Access Compliance Report

Public Rights-of-Way

(Pedestrian Signals)

Intersection ID: N/A	Main Street:	Cross Street: N/A	Location: N/A
ADA ID: AADCDFD87E629	Signal Type: One Push Button-Non APS	Overall Compliance: No	Severity Score: BTN 1: N/A BTN 2: N/A No BTN: N/A
Codes/Mitigation Info/Possible Solution		Field Measurements/Component Compliance

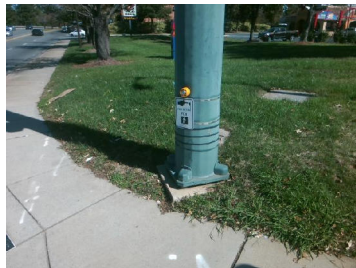
PROW/ADA: R209.1, TMUTCD 4e.08, R404.2, R404.3, R406.2

Yes	B 1 Clear Xing Direction?	ClearlyMarked	N/A	B 2 Clear Xing Direction?	N/A
	B 1 Crossing Direction	To NW		B 2 Crossing Direction	N/A
Yes	B 1 DistanceTo XWalk (in)	0.0	N/A	B 2 DistanceTo XWalk (in)	N/A
No	B 1 DistanceTo Curb (in)	85.0	N/A	B 2 DistanceTo Curb (in)	N/A
Yes	B 1 Diameter (in)	2.0	N/A	B 2 Diameter (in)	N/A

Possible Solutions: Replace Signal Push Button With APS Button on New Post. Remove & Replace Sign.
